Proposed Residential Development,
Dundrum, Dublin 14

Quality Audit

Document Ref: P21-138-UQA-GEN-RP-001

Drawing: E037-CSC-ZZ-XX-DR-C-0005 (Rev. P1)

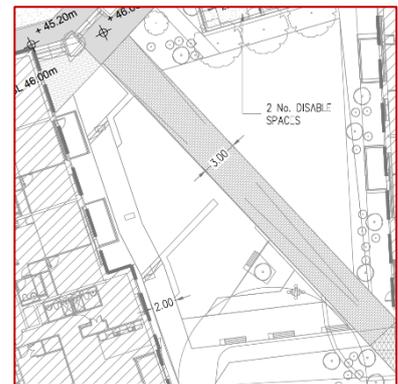
Summary: *The gradient of footways within the development is unclear and may lead to slips, trips and falls if steeper than 1:20.*

Ramps have been indicated throughout the footway network within the proposed development. The gradient of these ramps has however not been indicated. Should ramps be provided at a gradient that is in excess of 1V:20H, elderly, or mobility impaired pedestrians, particularly wheelchair users, and cyclists may experience difficulty ascending/descending the ramps resulting in potential slips and falls.

Ensure the proposed gradients are not steeper than 1V:20H.

Drawing: E037-CSC-ZZ-XX-DR-C-0005 (Rev. P1)

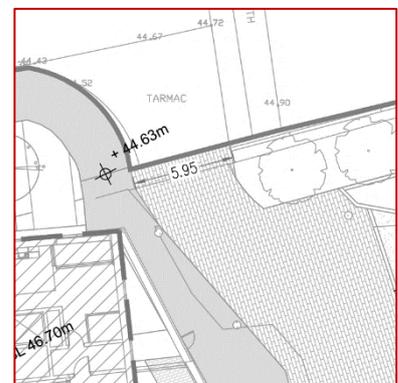
Summary: *Junction control, or priority, has not been indicated at the access to the proposed development.*

The junction control (stop, yield etc.), and thus priority, at the development's access has not been indicated. The absence of adequate road markings and signage may lead to driver confusion and hesitation resulting in drivers misinterpreting priority at the junction and entering the junction at the same time as opposing vehicles where there is an increased risk of side-swipe or side-on collisions.

Ensure the junction control, and priority, at the proposed development access is clear via signage and road markings.

Drawing: E037-CSC-ZZ-XX-DR-C-0005 (Rev. P1)

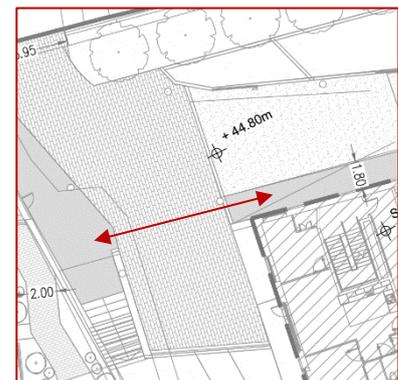
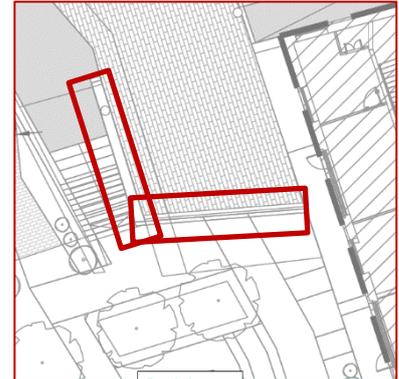
Summary: *A pedestrian crossing has not been indicated at the top of the basement carpark access ramp along the pedestrian desire line between Block A and Block B.*

Measures have not been indicated to allow pedestrians to safely cross from the footway in front of Block A to the footway in front of Block B at the top of the basement carpark access ramp, where a pedestrian desire line is likely to exist. Should pedestrians cross at this location, which is the shortest route between these footways, or elsewhere within the development, there is a risk that drivers entering/exiting the basement carpark will be less attentive to them increasing the risk of vehicle-pedestrian collisions.

A formal uncontrolled pedestrian crossing, including dropped kerbs and tactile paving if a level difference is proposed between the shared surface and footway, should be provided at the top of the basement carpark access ramp, ensuring drivers exiting the ramp have sufficient visibility to crossing pedestrians and cyclists.

Drawing: E037-CSC-ZZ-XX-DR-C-0005 (Rev. P1)

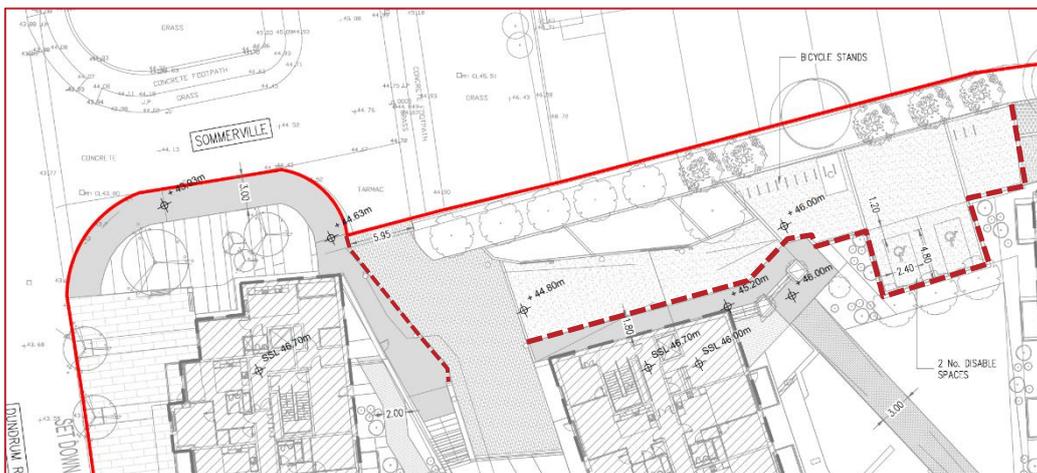
Summary: It is unclear if the footways at the development's ground level will be flush with the adjacent shared surface.

It is assumed that the route between the development access and the mobility impaired parking spaces/carpark at surface level is a shared surface. It is however unclear if the adjacent footways will be flush with the shared surface or at a different level. It is likely that visually impaired pedestrians will travel within the footways which will present a 'safe zone' for them where motorised vehicles will not enter. However, if the footways are flush with the shared surface, and a sufficient means of delineation not provided at the transition between the footways and shared surface, visually impaired pedestrians may inadvertently enter the shared surface leading to an increased risk of collisions with vehicles and cyclists.

If the footways and shared surface are flush a tactile strip should be provided at the transition between the two surfaces to advise visually impaired pedestrians of the transition. Sufficient colour contrast should also be provided between the two surfaces to further increase a visually impaired pedestrian's awareness of the road layout.

Drawing: E037-CSC-ZZ-XX-DR-C-0005

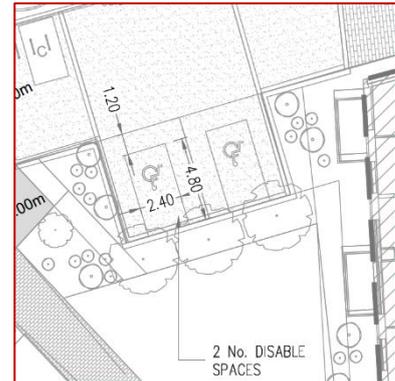
Summary: Absence of dropped kerbs and tactile paving at the mobility impaired parking spaces.

Mobility impaired parking spaces have been indicated adjacent to the northern side of the proposed development units.

It is unclear from the information provided if dropped kerbs and associated tactile paving are proposed at these parking spaces. The absence of dropped kerbs could lead to difficulties for mobility impaired road users in accessing the footpath once they leave their vehicle.

Provide dropped kerbs & tactile paving between the parking spaces to permit safe access to/from the footway.

Drawing: E037-CSC-ZZ-XX-DR-C-0005 (Rev. P1)

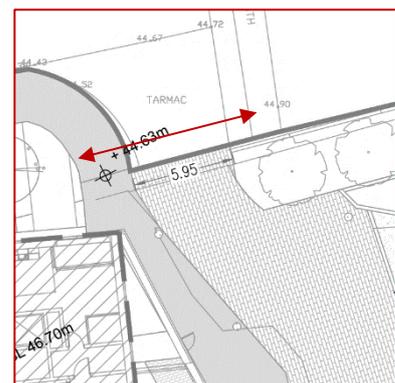
Summary: The existing footway on the eastern side of the Sommerville Estate access road terminates at the development boundary with no measures indicated for pedestrians to access the proposed footway on the western side of the road.

The existing footway on the eastern side of the Sommerville Estate access road terminates at the development boundary. Measures have not been indicated for pedestrians travelling to the development from the Somerville Estate to safely access the proposed footway on the western side of the road which is indicated as continuing into the proposed development. This could lead to pedestrians crossing the carriageway at a location where drivers may be less attentive to them increasing the risk of vehicle-pedestrian collisions.

Additionally, mobility impaired and visually impaired pedestrians will be unable to access the development from this footway resulting in them being unable to safely, and independently, navigate the road layout.

A pedestrian access to the development should be provided from the footway on the eastern side of the Sommerville Estate access road.

Alternatively, an uncontrolled pedestrian crossing should be provided at the development access to allow pedestrians access the western footway at this location. The crossing should be located where inter-visibility between drivers and crossing pedestrians is unobstructed.

Drawing: E037-CSC-ZZ-XX-DR-C-0005 (Rev. P1)

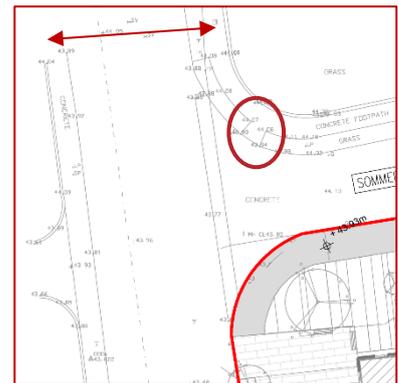
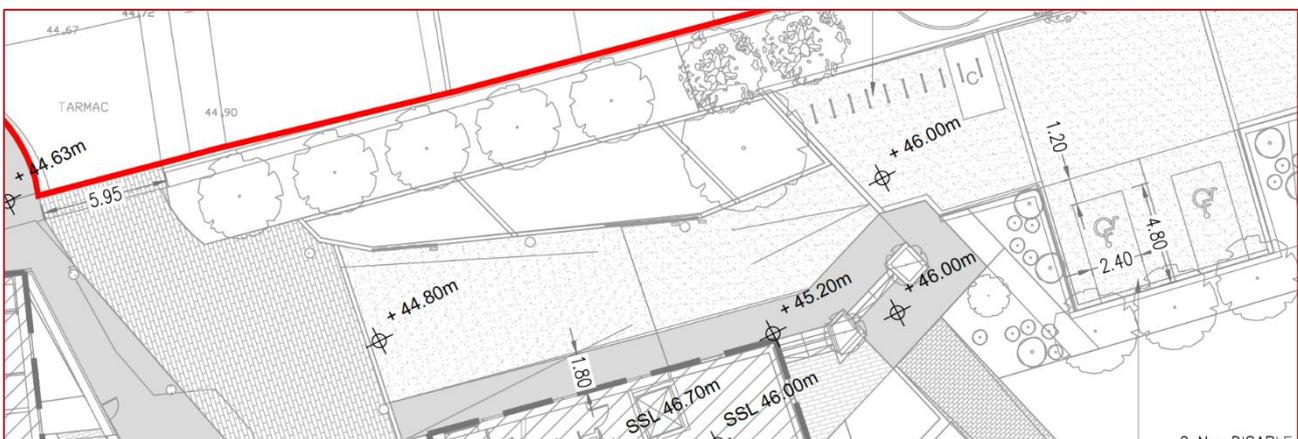
Summary: The route between Dundrum Road, to the north of the Sommerville Estate Access, and the proposed development does not include safe pedestrian crossing facilities for the visually and mobility impaired.

The route between Dundrum Road, to the north of the Sommerville Estate Access, and the proposed development does not include safe pedestrian crossing facilities for the visually and mobility impaired. There are existing dropped kerbs provided on either side of the Sommerville Estate access, however no tactile paving has been provided, nor do the dropped kerbs align with each other.

While it is acknowledged that this is outside the extents of the proposed development, it is likely that pedestrian trips generated by the proposed development will use this route to access public transport and other services located to the north. The lack of tactile paving at, and the alignment of, the crossing may lead to visually impaired pedestrians inadvertently entering the carriageway, and potentially being directed into the Dundrum Road carriageway rather than towards the opposing crossing point, where they are at an increased risk of being struck by a vehicle.

Additionally, there are limited existing pedestrian crossing facilities across the Dundrum Road to cater for pedestrian desire lines to/from the proposed development. If safe cross facilities are not provided along these pedestrian desire lines, there is a risk that pedestrians will cross at unsafe locations, increasing the risk of vehicle-pedestrian collisions.

The dropped kerbs on either side of the Sommerville Estate access should be amended such that they align with each other. The necessary tactile paving should also be provided at the dropped kerbs.

The developer should also liaise with Dún Laoghaire–Rathdown County Council to provide improved pedestrian crossing facilities across the Dundrum Road in the vicinity of the proposed development.

Drawing: E037-CSC-ZZ-XX-DR-C-0005 (Rev. P1)

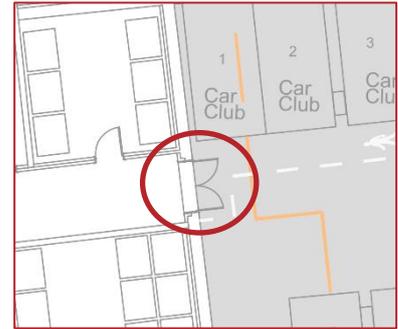
Summary: It is unclear if there is sufficient space provided for vehicles to safely travel along the road layout within the proposed development.

It is assumed that the route which circumnavigates Block B is intended for access for emergency vehicles (e.g. ambulance, fire tender etc.). Information regarding the swept path of vehicles has not been provided to the Audit Team and it is therefore unclear if these vehicles can safely enter, travel within, and exit the proposed development's road layout.

If sufficient space is not provided for vehicles to travel within the development, there is an increased risk of unsafe manoeuvres and material damage collisions, particularly where vehicle movement is restricted by overhanging or adjacent structures.

Ensure sufficient space is provided within the development for vehicles to safely enter, travel within, and exit the proposed development's road layout.

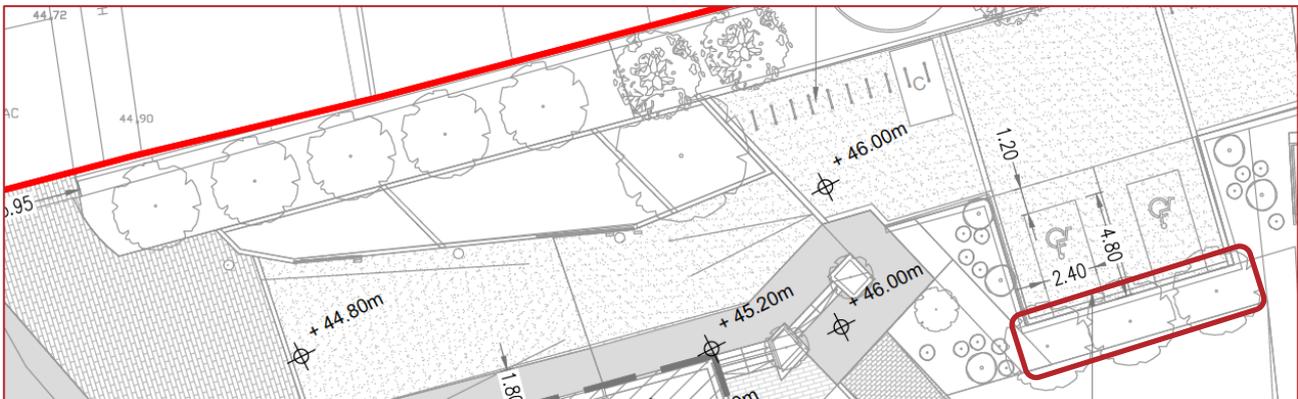
The path immediately to the rear of the mobility impaired parking spaces at surface level appears to be blocked by trees and may not be accessible for the mobility impaired, particularly wheelchair users, after exiting their vehicle. If this path is not directly accessible from these parking spaces, it is likely that mobility impaired drivers/passengers will have to travel a longer route through the shared surface to access the apartment blocks.

Ensure the path adjacent the mobility impaired parking spaces is free of all obstructions and that mobility impaired pedestrians can access this and have a continuous route between this location and both apartment blocks.
